**Subject: RESPONSE TO CITY OF SAN DIEGO
DEVELOPMENT SERVICES DEPARTMENT
REVIEW COMMENTS PERTAINING TO
REPORT OF GEOTECHNICAL INVESTIGATION
SEWER AND STORM DRAIN GROUP JOB 828 REPLACEMENT PROJECT
CITY OF SAN DIEGO
AGE Project No. 179 GS-16-F**

**UPDATED REPORT OF
GEOTECHNICAL INVESTIGATION
SEWER AND STORM DRAIN GROUP JOB 828
REPLACEMENT PROJECT
CITY OF SAN DIEGO**

AGE Project No. 179 GS-16-F

FIGURE 2

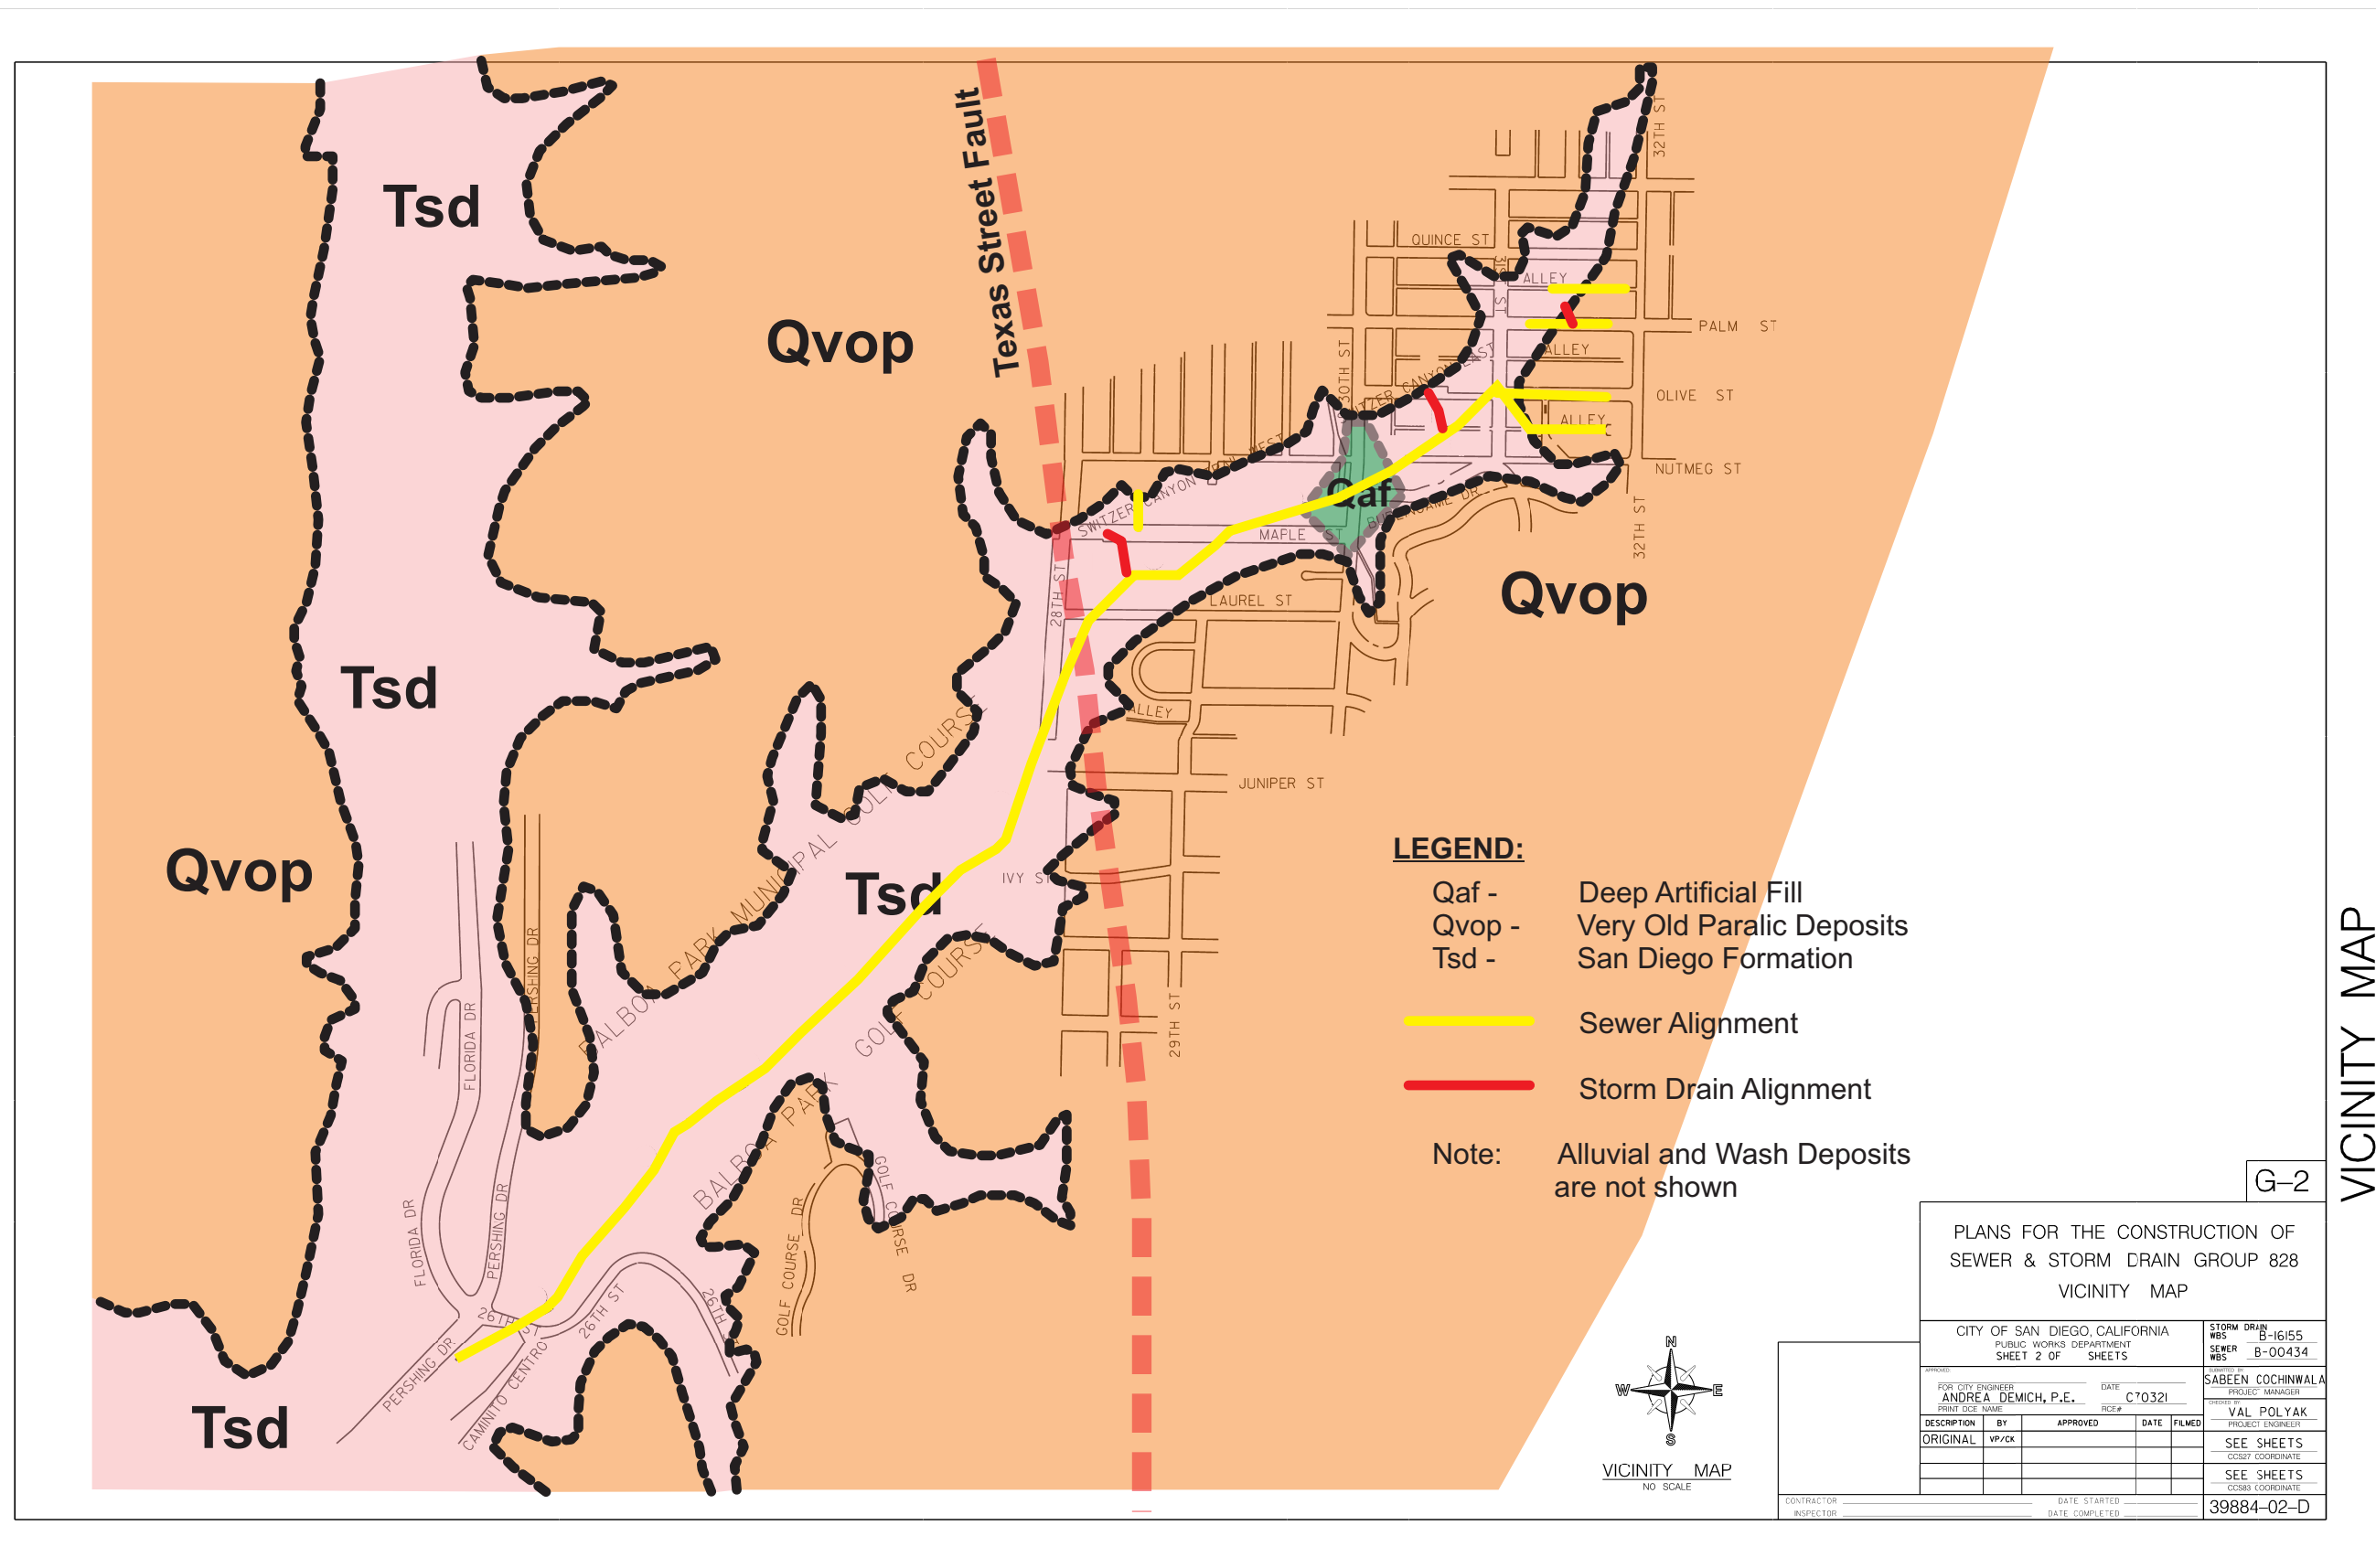
No.	Development Services Department Comment	AGE Response
4	Circumscribe the limits of anticipated remedial grading on the geologic/geotechnical map to delineate the proposed footprint of the project.	Earthwork operations for the proposed project are anticipated to be limited to conventional cut-and-cover trenched construction and trenchless construction. No remedial grading is anticipated for the proposed project.
5	The geotechnical investigation report must contain representative geologic/geotechnical cross-sections for the areas of the proposed slope reconstruction that show the existing and proposed grades, distribution of fill and geologic units, and approximate location of the proposed key and benches.	The scope of the current project does not include any slope reconstruction.
6	The project's geotechnical consultant should clarify if the proposed construction will destabilize or result in settlement of private structures or the public right of way.	Since the proposed project is limited to conventional cut-and-cover trenched construction and trenchless pipeline construction, and no grading is anticipated, it is our opinion that the proposed project is not anticipated to destabilize or result in settlement of adjacent property of the right-of-way, nor will the proposed improvements add surcharge on existing improvements or structures. Refer to Section 5.7 - Summary and Conclusions of the report.
